European Tyre and Rim Technical Organisation

Brussels, 11 February 2003
TAL062-03-ETR-WP29-TRNOISE

Subject : **Tyre/Road Noise**

Document : TRANS/WP29/2002/7/Rev.1

Example 1

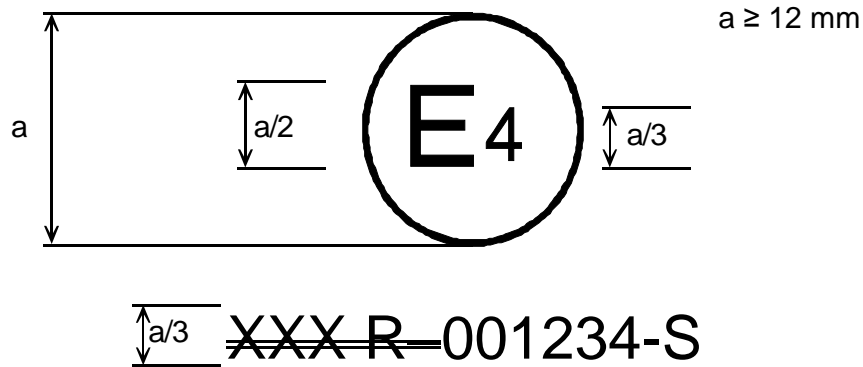
ETRTO requests to revise in Annex 2 the examples of 'arrangements of approval marks' (three times) in order to delete 'XXX R-' in front of the approval number for the following reasons:

1. the examples in the annex should conform to the text in item 5.4.2 where it is specified that only the type approval number followed by the letter '-s' shall be placed close to the circle. The form of 'communication' in Annex 1 refer to the number of Regulation (XXX) only in the title and does not repeat it underneath were it is to be specified the 'Approval No.?

2. the suffix marking ('-s'), which shall be stamped in any case, will permit to identify that approval number as related to the given regulation without any possibility of confusion with other regulations. Marking as in the example 'XXX R-' will be nothing else than a repetition and therefore a redundant specification.

The above approval mark, affixed to a pneumatic tyre shows that the tyre concerned has been approved in the Netherlands (E4) pursuant to Regulation No. XXX (**marked by "-S" only**), under approval number 001234. The first two digits of the approval number (00) indicate that the approval was granted according to the requirements of this Regulation in its original form.
